Proposal for amendments to Regulation No. [xxx] (the Moving Off Information System for the Detection of Pedestrians and Cyclists)

The text reproduced below was prepared by the experts from the VRU-Proxi Informal Working Group (VRU-Proxi) to amend the new UN Regulation on uniform provisions concerning the approval of motor vehicles with regard to the Moving Off Information System for the Detection of Pedestrians and Cyclists. The modifications to the existing text of the draft Regulation (see GRSG-118-06) are marked in bold for new or strikethrough for deleted characters.

Submitted by the experts from VRU-Proxi Informal Working Group

Informal document No. GRSG-120-xx
(120th GRSG, ... 2021
agenda item xx)

Figure 1

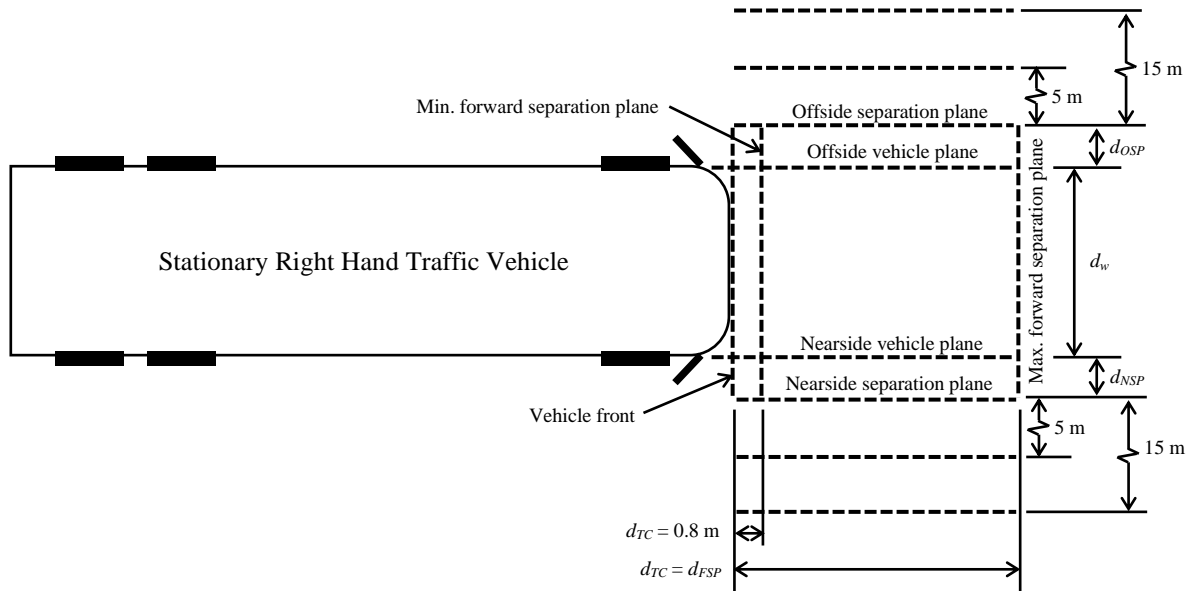
Appendix 1, amend to read:

- d_w vehicle width.
- ~~$d_{25\%}$ a distance relating to 25% of the vehicle width.~~
- d_{NSP} the distance from the nearside vehicle plane to the nearside separation plane, defined as 0.5 m.
- d_{OSP} the distance from the offside vehicle plane to the offside separation plane, defined as 0.5 m.
- d_{TC} the forward separation distance for each test case.
- d_{FSP} the distance from the vehicle front to the maximum forward separation plane.
- ~~d_{LPI} the distance relating to the last point of information (LPI).~~

1. Justifications for paragraph 5.2.2.3.3.: MOIS focuses on straight driving situations. As the testing procedure is not defined, this part of the requirement may lead to too many testings.
2. Justifications for paragraph 5.5.1.: In VRU-Proxi#14, we agreed to use the word initialisation instead of calibration to be in line with the wording used in the AEB regulation. The MOIS (and the AEB) needs driving situations to initialise the system.
3. Justifications for paragraph 5.8.3.: 5.8 deals with failure warning signals.
4. Justifications for Appendix 1.: clarifications of the definitions listed for the table 1 and figure 1.
